**STATEMENT OF CASE
ADDENDUM**

Site: Land East of Oxhey Lane
Carpenders Park
Hertfordshire

Appeal Ref:
APP/P1940/V/26/3378268

Place Services Landscape Comments November 2025

Visual context

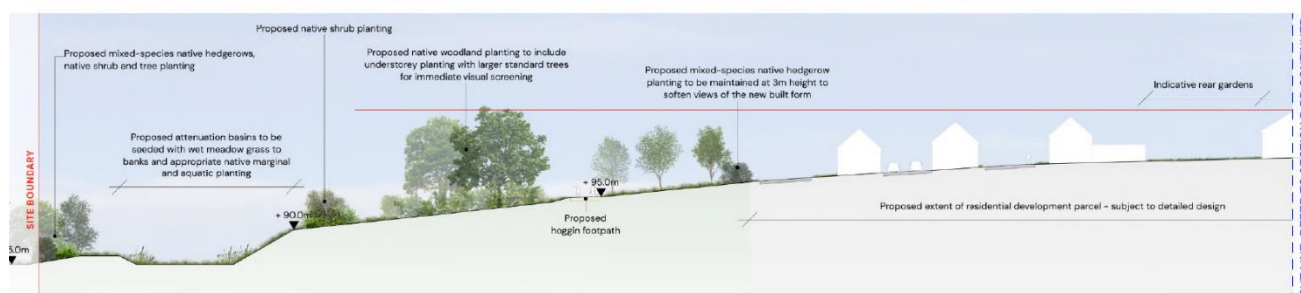
The relationship between the site and the built edge of settlement is not questioned. But we consider that the site also has a visual connection with the rural landscape with views to the south from the mid and southern site parcels, although we acknowledge these are not publicly accessible locations. The LVIA has recognised open views to the west and panoramic views southeast.
